Re: ABP case reference : PAX07.323761

Applicant : Neoen Renewables Ireland Limited

Located within the townlands of Cloondahamper, Cloonascragh, Elmhill, Cooloo, Lecarrow, Dangan Eighter, Lissavally and Slievegorm, Co.Galway

Map 1

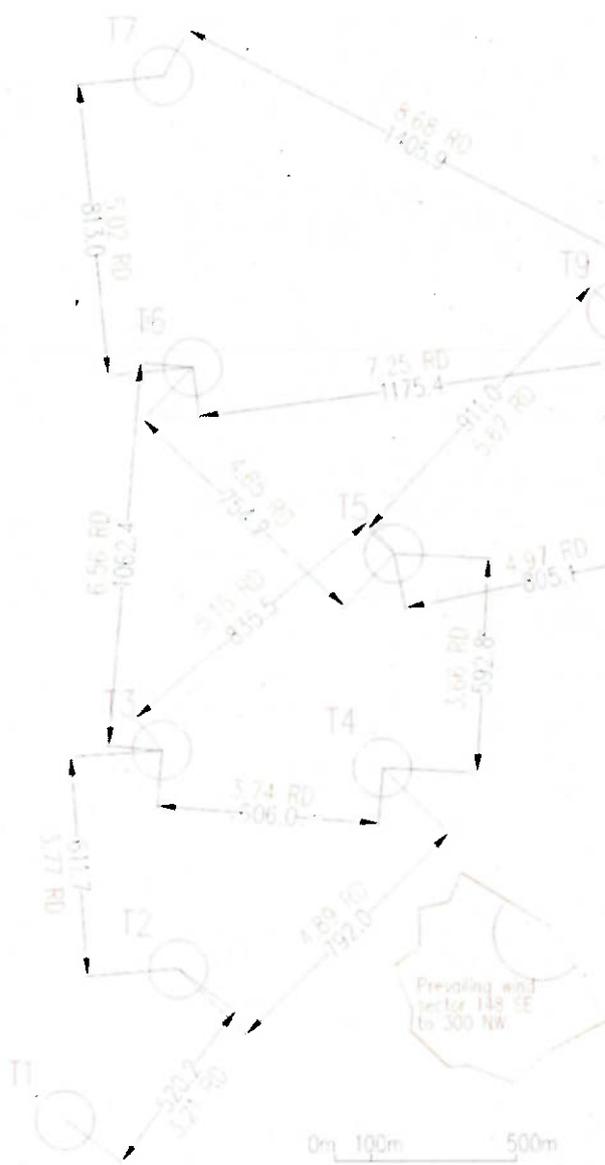
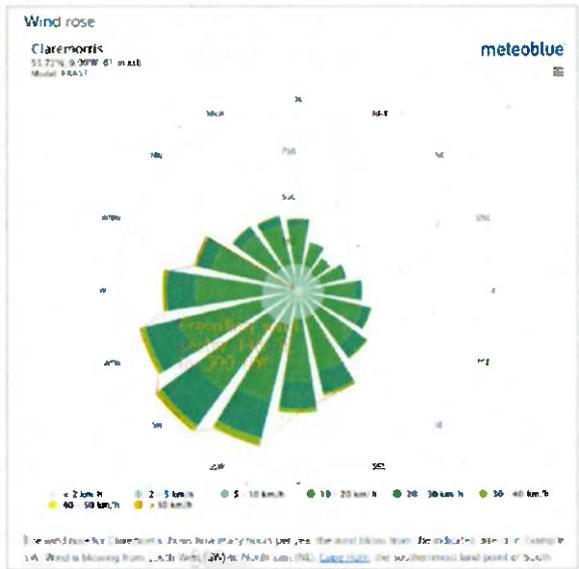
In ABP case reference **323761** to which this observation refers, the applicant has, as one can see in Map 1, next page, ignored the turbine separation distances from adjacent turbines, that are recommended in the WEDG2006 guidelines.

It should be noted that the prevailing winds, those requiring 7 rotor diameter separation distance between turbines, are not only from the southwest direction. Map 1 shows that in reality there are strong and frequent winds from 140 deg. Southeast to 300 deg. Northwest in a clockwise direction.

The following turbine spacing arrangements fail the required WEDG 2006 guidelines.

Therefore 9 sets of turbines fall short of WEEDG2006 guidelines.

Failing turbine sets:

Less than 7 RD are T3 to T6.

Less than 6 RD are T5 to T9 & T6 to T7.

Less than 5 RD are T5 to T8, T2 to T4.

Less than 4 RD are T1 to T2, T2 to T3, T3 to T4, & T8 to T9.

T5 to T6 pass as they are in a crosswind direction.

T6 to T9 & T7 to T9 pass as they are more than 7 rotor diameters apart in prevailing wind.

Therefore turbines must be 1134m (7.00 RD) apart in the prevailing downward wind direction.

On the basis of what I have outlined and experienced, I highly recommend the aforementioned issues be carefully considered, and the design be altered significantly.
